Memorandum

To:	Scott Storment, EAHCP Program Manager
From:	Christa Kunkel, Kyle Sullivan, Ed Oborny, Brad Littrell, Casey Williams, Matt Pintar, BIO-WEST Lucas Bare, ICF
Date:	March 7, 2024
Re:	Revised Recommended Biological Goals and Objectives for the Permit Renewal

Edwards Aquifer Habitat Conservation Plan, Recommended Biological Goals and Objectives for the Permit Renewal Comment Response

Figure 2. Fitted Predictions of Discharge as a Function of 30-day Average Springflow across Eight Stations in the Comal System

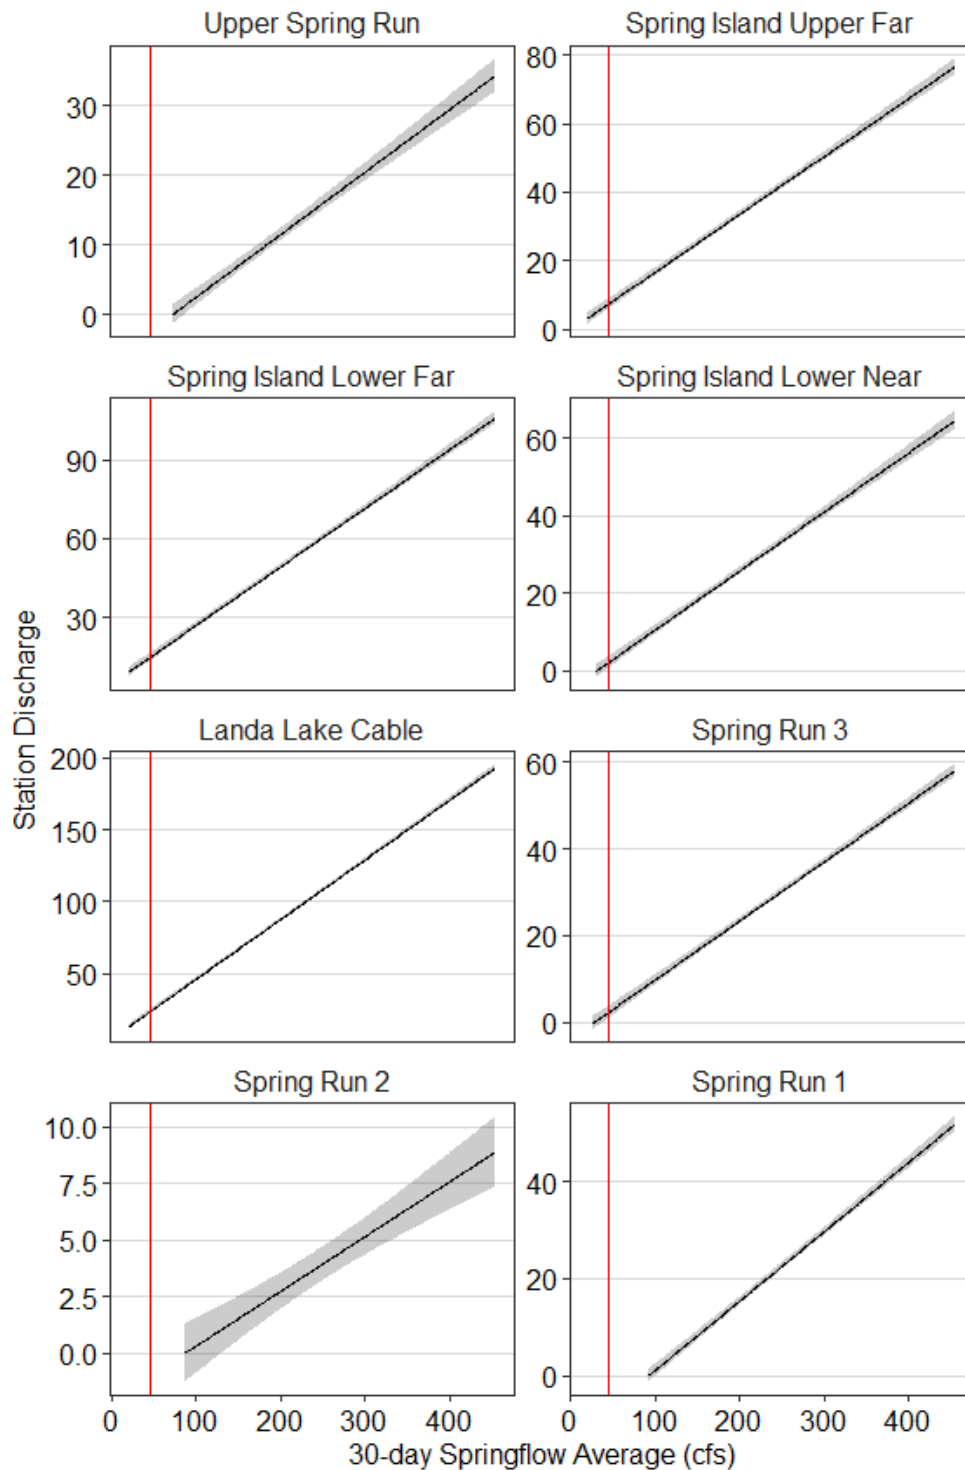
8	Figure 2	Conrad Lamon	SC	shows only (partial) uncertainty in slope, and therefore it's a CI about the slope, not fitted values. Fitted predictions (or residuals), if they were shown, would also include prediction intervals, which account not only for the uncertainty in slope, but also of observations about that uncertain slope (see, for instance, Fig 2.7, Lawrence C Hamilton, Regression with Graphics, Duxbury, Belmont California, 1992.). So, the 1-alpha CI will be slope estimate +/- t (alpha, df) * (SE). So instead of slope +/- SE it's actually a 50% CI with df=1. Unusual choice.
9	Table 2	Conrad Lamon	SC	Need prediction intervals here, not just +/- SE. Are we afraid they will include zero? We should be, and the probability implied by these models of doing so should be quantified and stated. That makes for better risk assessment.
10	6	Conrad Lamon	SC	should be annual average not average annual. Both in text and on figure 3 caption

Regarding the comment about RMSE for the fitted model, we agree that “highly accurate” may be an exaggeration, though we believe that “accurate” is a reasonable descriptor of performance. RMSE should be put into context with the distribution of the response variable and requirements of the problem being addressed. Given that discharge across stations ranged from 0 to 166 cfs and that variability of the middle 50% of observations (i.e., interquartile range) was ~35 cfs, we argue that an average prediction error of ~5 cfs is accurate. The range of discharge across stations can be added into the results to provide context for RMSE estimates.

ACTION: The revised memorandum includes descriptions of the methods for model fitting to make the procedures easier to understand for the reader and clarifications have been made to better explain the methods of centering and scaling.

Figure 4. Long-Term 3-year Average Annual Springflow Trends in the Comal and San Marcos Rivers

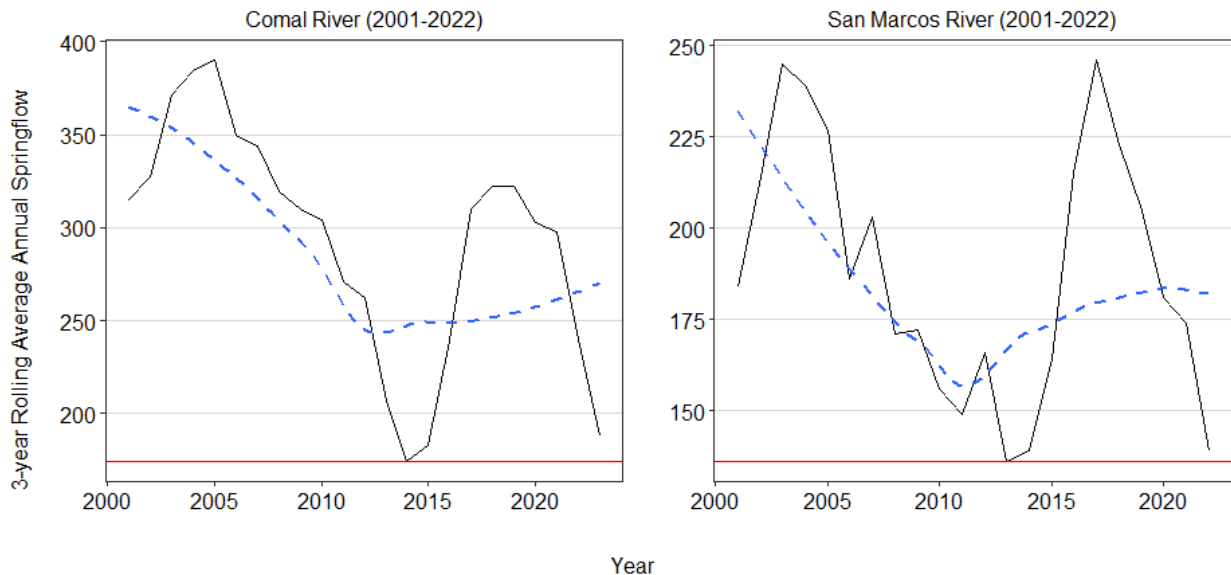
11	Figure 4	Robert Mace	TXST (IC-SH)	Unclear what the LOESS smooth functions are here for (not discussed in text)--they added confusion. If they are kept, then the caption needs to describe what the black lines are.

Figure 14. Boxplots Displaying Drop-Net Densities among Vegetation Types in the Comal and San Marcos Springs Systems

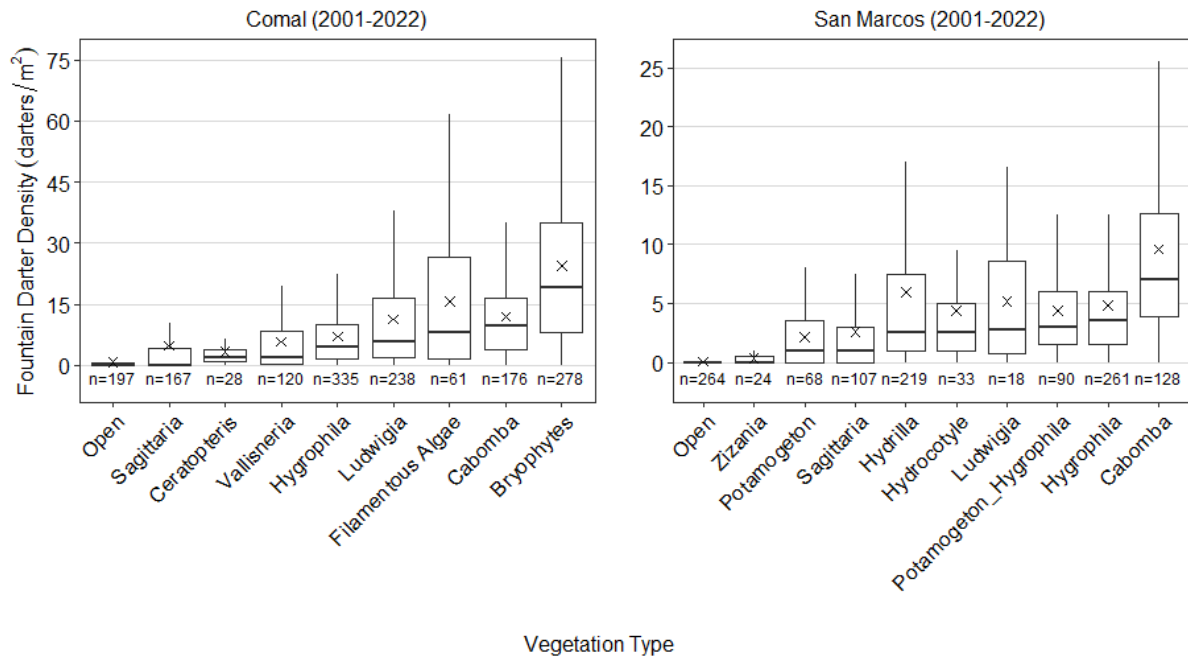
P. 30	lines 12-13	Myron Hess	SH Chair	Although I find Figure 14 difficult to interpret with any precision in terms of number of sampling events, it appears that most occurrences below the proposed criterion occurred prior to implementation of the EAHCP and thus prior to efforts aimed at management of vegetation and recreation. That is true for the three consecutive events occurring in 2001. Figure 16 also appears to be consistent with that interpretation. Accordingly, it is unclear how to interpret those data and some elaboration would be helpful, including clarification of whether data in the table are limited to LTBG reaches.

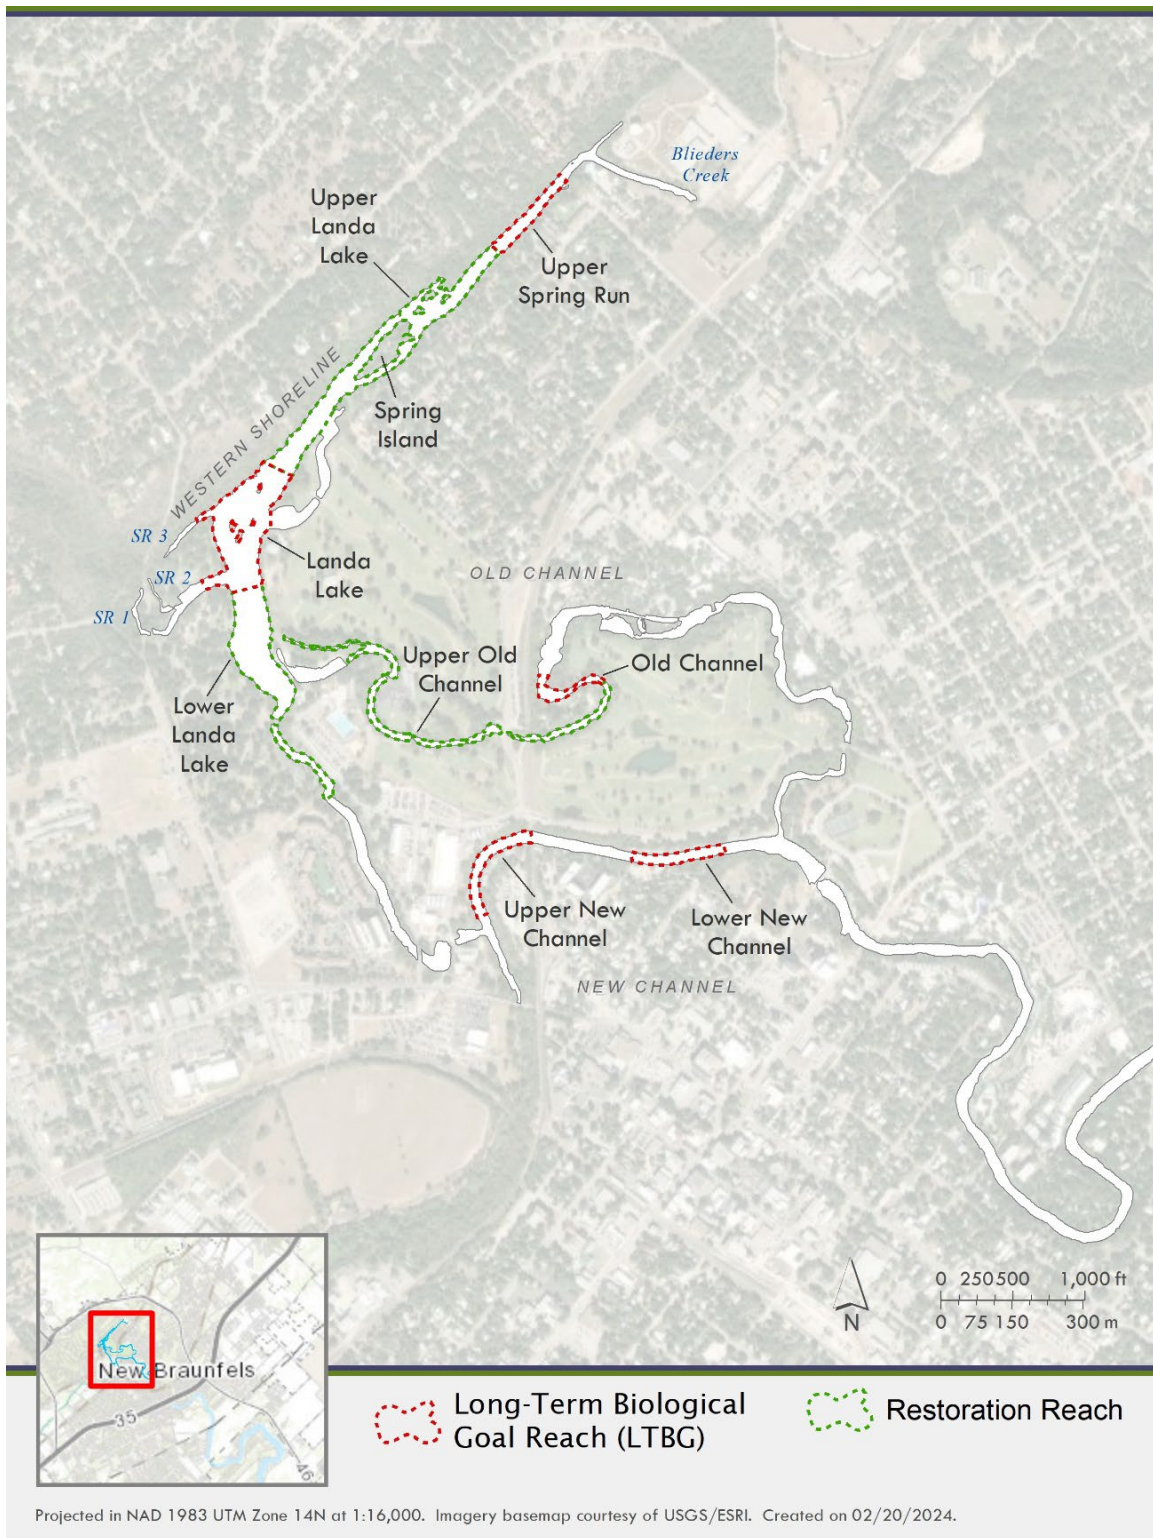
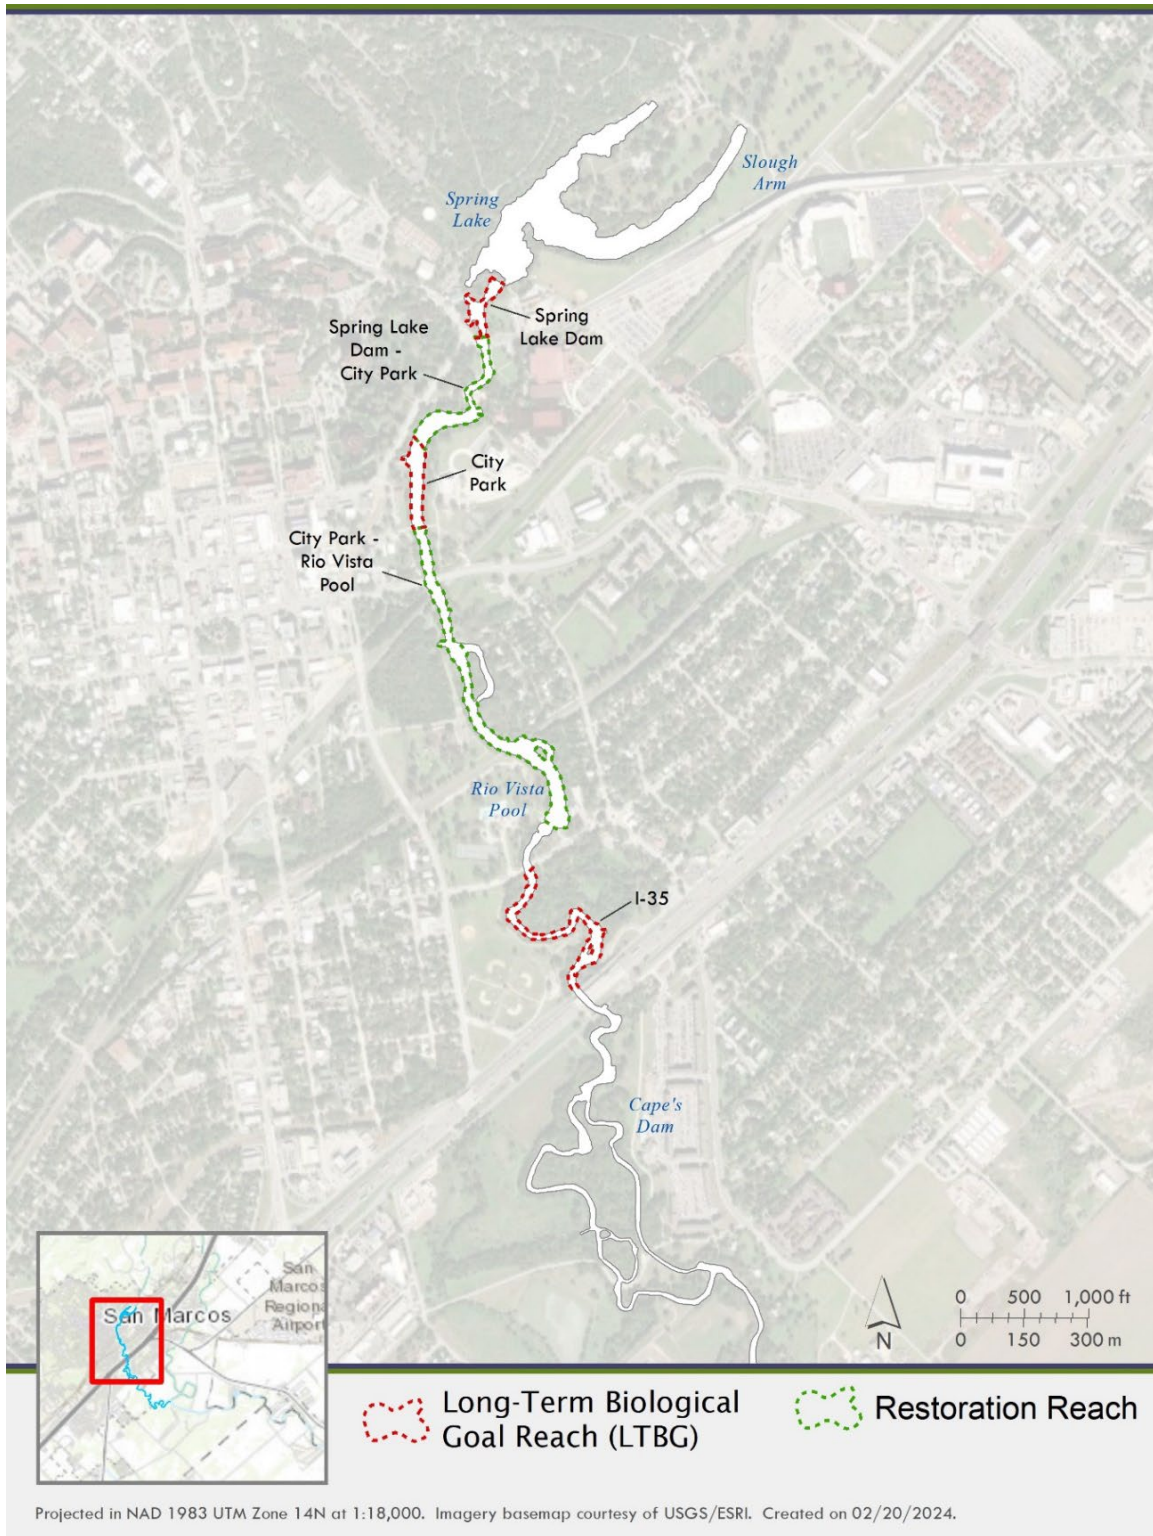
36	line 10, Figure 18	Kimberley Meitzen	TXST (IC-SH)	I think it is good to maintain the consistency of using the LTBG reaches, but given the 30 year permit- it may be a good idea to provide an objective to add new reaches, or be more flexible with the spatial area of the LTBG reach - for example adding an upstream or downstream buffer based on different system stressors, for example recreation in the City Park reach can have a big effect on the upstream portion of that reach and as shown in Figure 18 and 19 this reduces the complex and simple SAV coverage.
34	Table 8	Kimberley Meitzen	TXST (IC-SH)	Add bryophyte to San Marcos list, include Heteranthera for San Marcos list (not sure if it should be complex or simple), provide a place holder for another regionally native veg type that may be added to the system in the future.
36-37	line 10 (Page 36) - line 3 (page 37)	Kimberley Meitzen	TXST (IC-SH)	It may be beneficial to approach this from more of a system-wide approach instead of by the LTBG reaches. Would it be possible to quantify areal coverage for longer river segments similar to the TWR objectives?

Additional reaches outside of the Long-Term Biological Goals study reaches were added in each system to provide better spatial representation of each system. These restoration reaches are as follows and are displayed in Figures 19 and 20 in the revised memorandum:
